NOTICE OF DECISION

CLASS 3 SITE PLAN REVIEW / CLASS 2 ADJUSTMENT / CLASS 2 DRIVEWAY APPROACH PERMIT CASE NO.: SPR-ADJ-DAP23-24

APPLICATION NO.: 22-117603-PLN

SUMMARY: Proposed new 31,814 square-foot, three-story, medical/office building with associated site improvements and off-street parking.

PROPOSED SITE PLAN

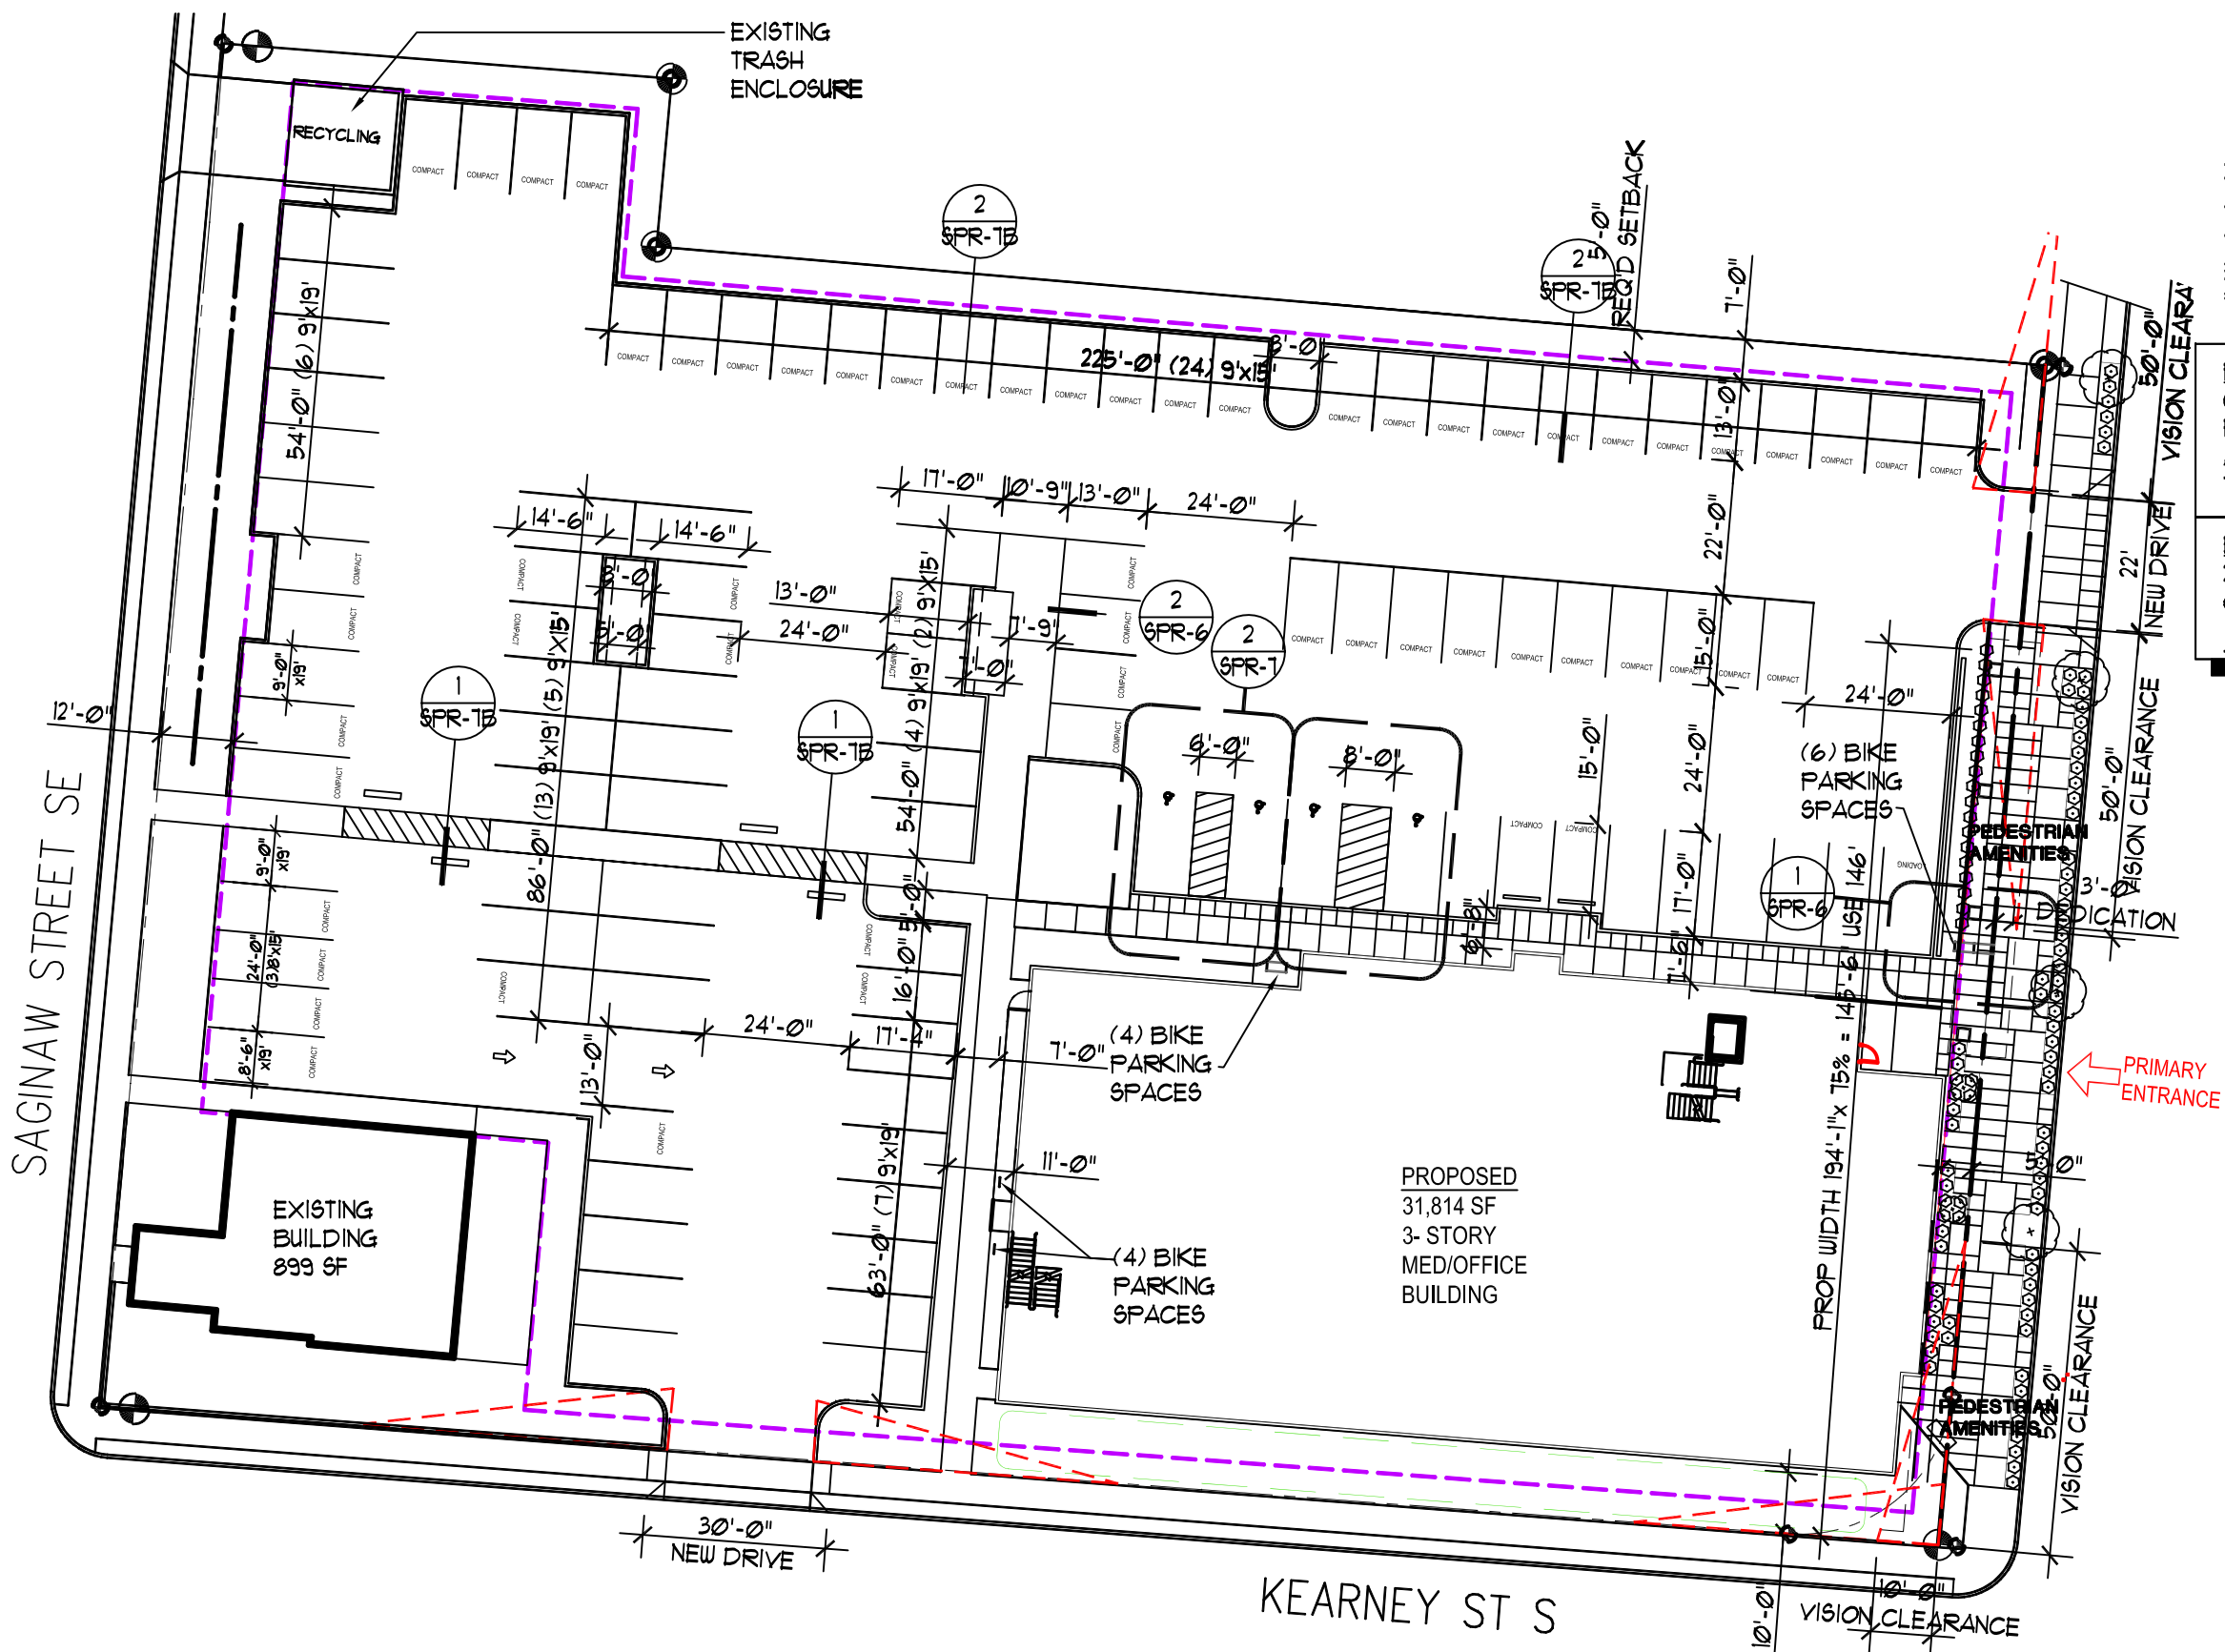
As shown on the site plan, the proposed new medical/office building is setback 10 feet from Kearney Street, and the area between the building and Kearney Street is proposed to be developed with a stormwater water quality facility. As required under the MU-I zone, a maximum setback of 10 feet from a street is only allowed when the setback area is developed with a pedestrian amenity. SRC 533.005 defines “pedestrian amenity” as, “...areas and objects that are intended to serve as places for public use and are closed to motor vehicles. Examples include plazas, sidewalk extensions, outdoor seating areas, and street furnishings.”

As shown on the site plan, the proposed new medical/office building is setback approximately five feet to eight feet from Commercial Street and the area between the building and the street is proposed to be developed with pedestrian amenities including a sidewalk extension that is accentuated with areas of landscaping. In addition, the proposed new building also includes an attached canopy structure that extends north from the building along Commercial Street to provide weather protection along the street together with benches where pedestrians are able to sit. The columns supporting the attached canopy structure are setback approximately 2.5 feet from the property line abutting Commercial Street and the roof structure of the canopy projects into Commercial Street as permitted under SRC 533.015(h), Table 533-6, which allows awnings and canopies to project into the public right-of-way. The proposed new medical/office building conforms to the setback requirements of the MU-I zone abutting Commercial Street.

As shown on the site plan, the proposed new medical/office building occupies approximately 49 percent of the building frontage of the property abutting Kearney Street and approximately 34 percent of the building frontage of the property abutting Commercial Street. As such, the proposed building exceeds minimum building frontage requirements abutting Kearney Street but does not conform, however, to minimum frontage requirements abutting Commercial Street. Because the proposed building does not meet the minimum building frontage requirements of the MU-I zone abutting Commercial Street, the applicant has requested a Class 2 Adjustment to this standard. Analysis of the Class 2 Adjustment request and findings demonstrating conformance with the Class 2 Adjustment approval criteria are included under Section 8 of this decision.

As shown on the site plan and building elevation drawings, a primary building entrance is proposed at the northeast corner of the building. The proposed entrance faces Commercial Street but does not, however, include weather protection. In order to ensure the proposed building entrance includes weather protection as required by the standard, the following condition of approval shall apply:

- Condition 1:** In order to accommodate fire department aerial access, the parking lot drive aisle adjacent to the west side of the proposed building shall be widened to a minimum width of 26 feet as shown on the revised site plan included as Attachment I to this decision.

PROPOSED LANDSCAPE PLAN

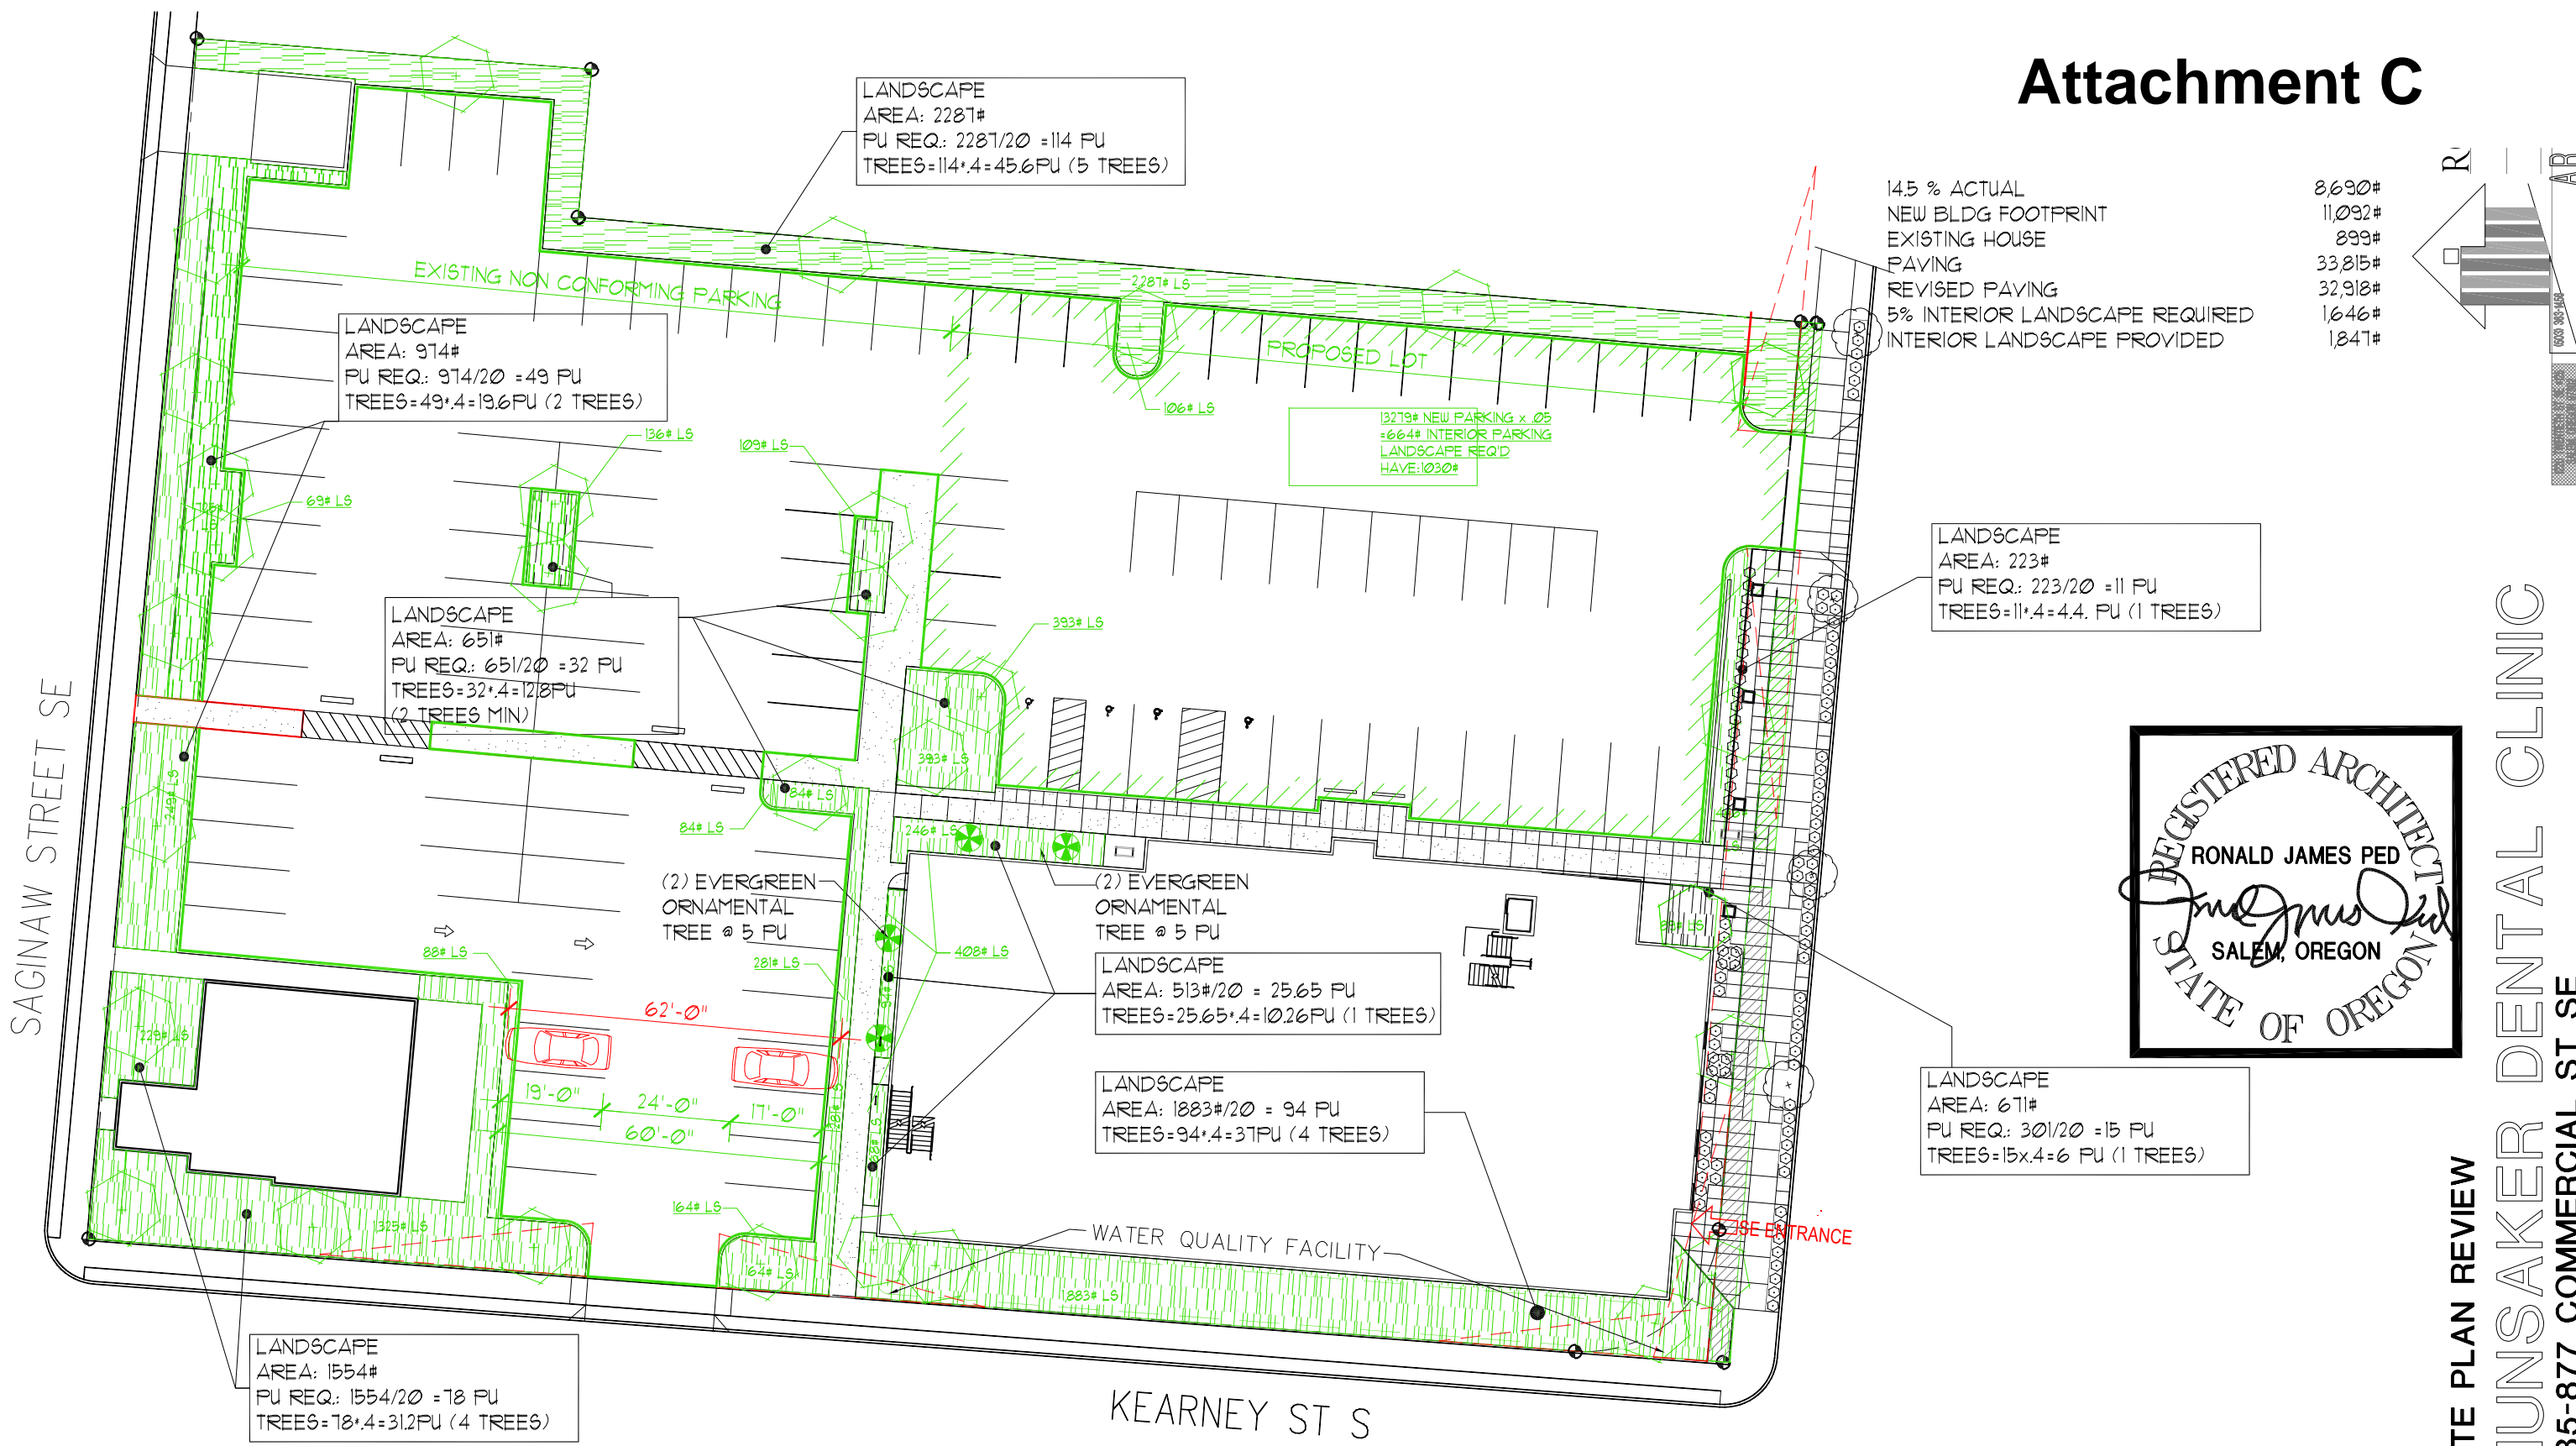
Based on the 108 off-street parking spaces proposed, a minimum of nine deciduous shade trees are required. As shown on the applicant's landscape plan, a total of 13 trees are proposed within the off-street parking area. However, of the 13 trees identified, some are proposed to be planted abutting each other within landscape planter bays that can only accommodate the planting of one deciduous shade tree rather than the two proposed. In order to ensure that the interior parking lot landscaping requirements of SRC 806.035(d)(3) are met the following condition of approval shall apply:

Although a landscape plan was submitted for the proposed development, the landscape plan does not identify the specific species of plants that will be planted in the identified landscape areas. In order to ensure that the landscaping provided for the proposed development conforms to the planting density requirements of SRC Chapter 807, the following condition of approval shall apply:

- Condition 3:** A minimum of nine deciduous trees shall be planted in the proposed off-street parking area of a species that meets the definition of shade tree under SRC 807.005.

- Condition 4:** At the time of building permit review, the applicant shall provide a full landscaping plan in conformance with the minimum plant unit density requirements of SRC Chapter 533, SRC Chapter 625, and SRC Chapter 807.
